Hovey
Industries Ltd.

Field Amendment Notice 01-002

SUBJECT:	Incorrect field wiring of Hovey switch heaters.	FAN NO.	01-002
CONCERN:	Personnel safety hazard. Plans issued by UP headquarters to the field show incorrect wiring between the signal bungalow and the heaters. When wired according to the plans, disconnecting the heater panel breaker does not guarantee that the panel is de-energized.	DATE	Oct 2, 2001

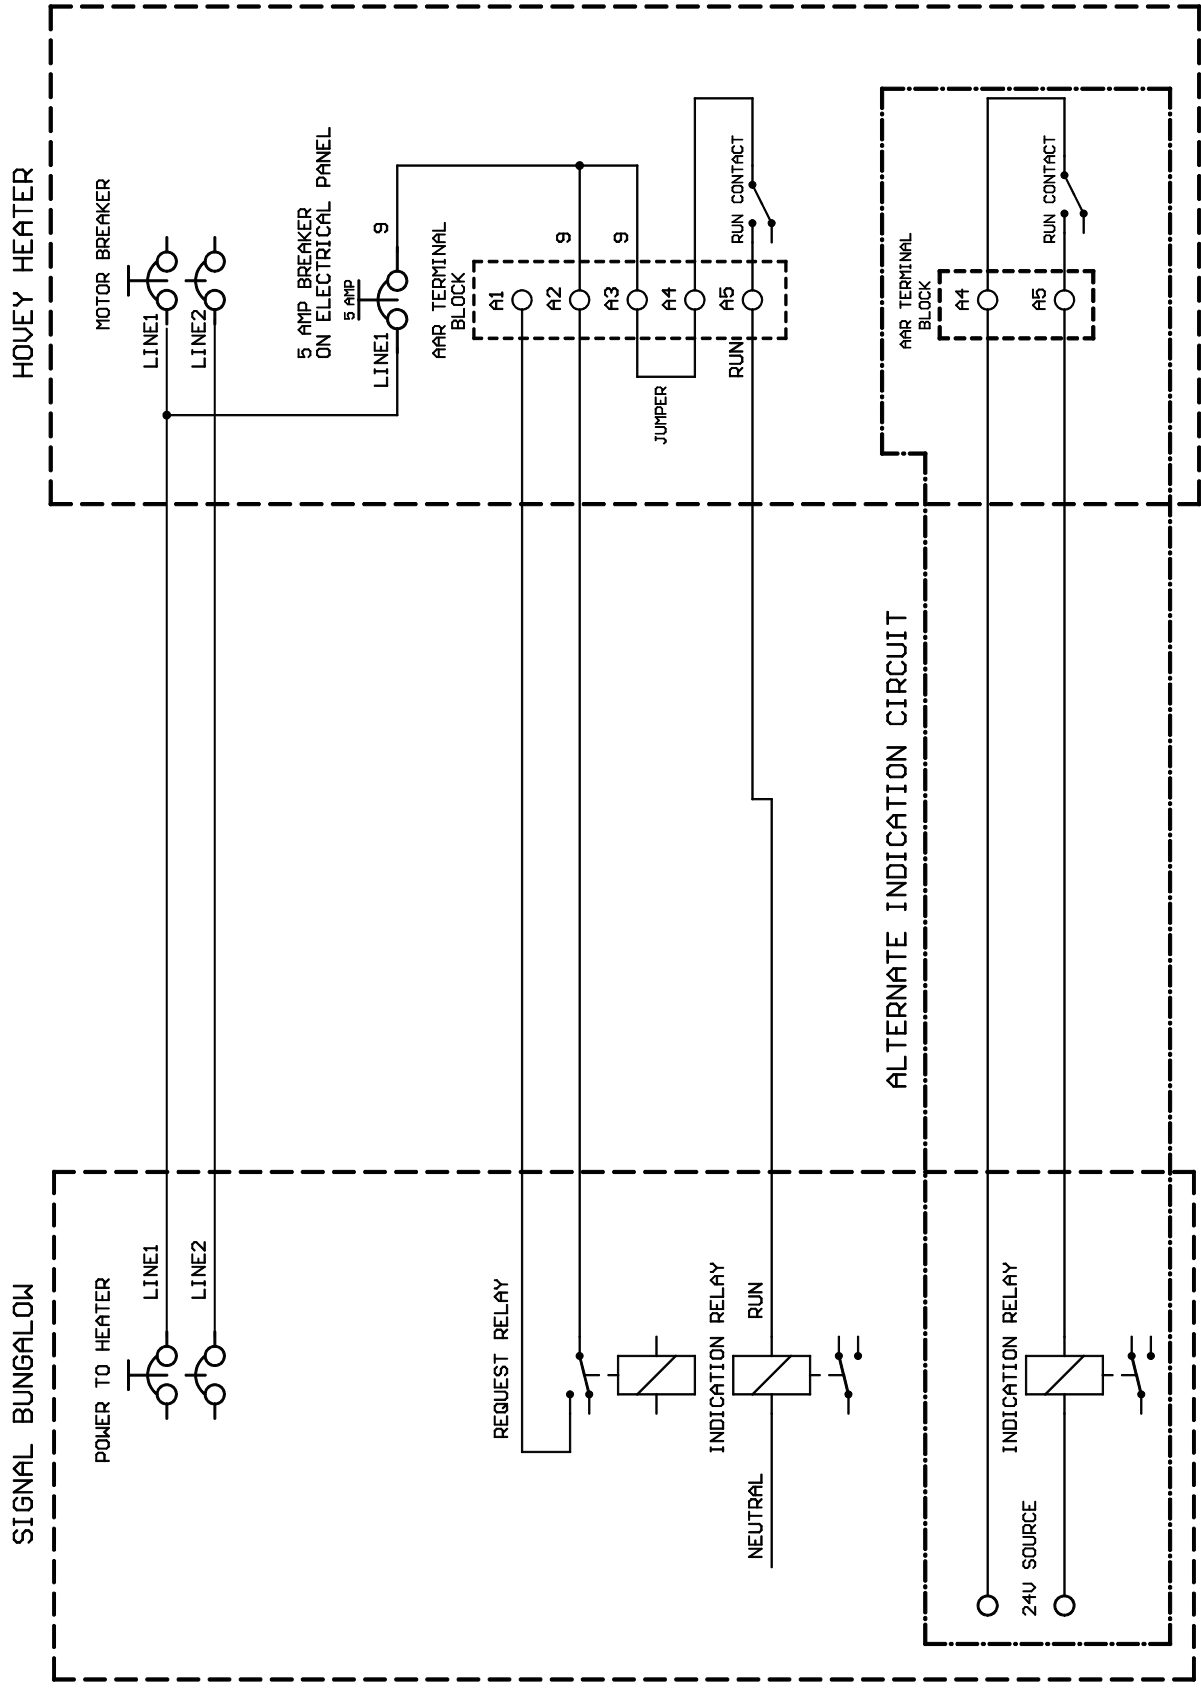
Models Affected:	All Hovey Mark 6 bungalow enclosed, small enclosure and HELLFIRE 900's.
Problem	Plans issued by UP headquarters to the field show incorrect wiring between the signal bungalow and the heaters. A separate source of 120Vac is supplied from the signal bungalow to terminal A1 of the heater. Such wiring creates a personnel safety hazard. With the heater requested by dispatch the electrical panel is energized, with 120Vac, the heater will operate, with the local panel circuit breaker opened.
Corrective Action	Correct the wiring to provide a relay contact closure between terminals A1 and A2. Review field wiring against Hovey schematic 17676A (next page). Make corrections as necessary. Customers with questions can contact Hovey Industries Ltd. at 613-822-1765 for assistance.
